WATER LICENCE INSPECTION FORM

Licensee		Licensee Representative	
Baffinland Iron Mines Corporation (BIMC)		Laura TAYLOR/Allan KNIGHT	
Licence No. / Expiry		Representative's Title	
2AM-MRY1325		Environmental Manager	
Land / Other Authorizations		Land / Other Authorizations	
8BC-MRY1416, 2BE-MRY1421		N2014X0012, N2014Q0016, N2014C0013	
Date of Inspection		Inspector	
May 29 - June 1,2017		Jonathan MESHER	
Activities Inspected			
<input checked="" type="checkbox"/> Camp	<input type="checkbox"/> Drilling	<input checked="" type="checkbox"/> Mining	<input checked="" type="checkbox"/> Construction
<input checked="" type="checkbox"/> Roads/Hauling	<input type="checkbox"/> Other:		<input type="checkbox"/> Reclamation
		<input type="checkbox"/> Other:	<input type="checkbox"/> Fuel Storage

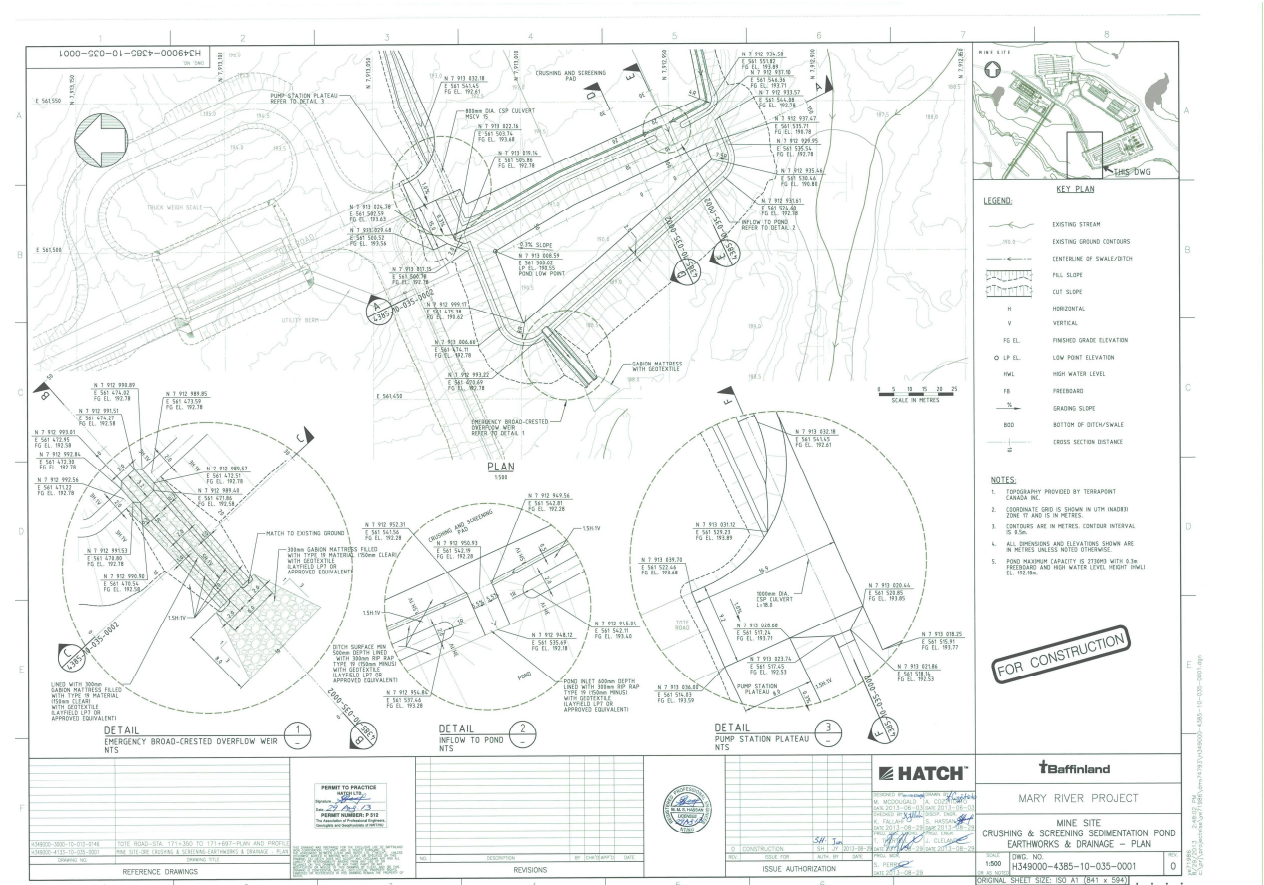
- c. During the Inspection it was noted that there was no culvert in place to allow water from the North West unlined ditches to enter the sedimentation pond, this is a concern to the inspector because in the HATCH for construction drawings below (Figure 1) it shows that there should be a 1000mm DIA CSP culvert installed.

- i. The inspector is requesting that the culvert be installed before freshet 2018.
 - ii. Samples were collected by the inspector to ensure no waste has entered the surrounding environment.
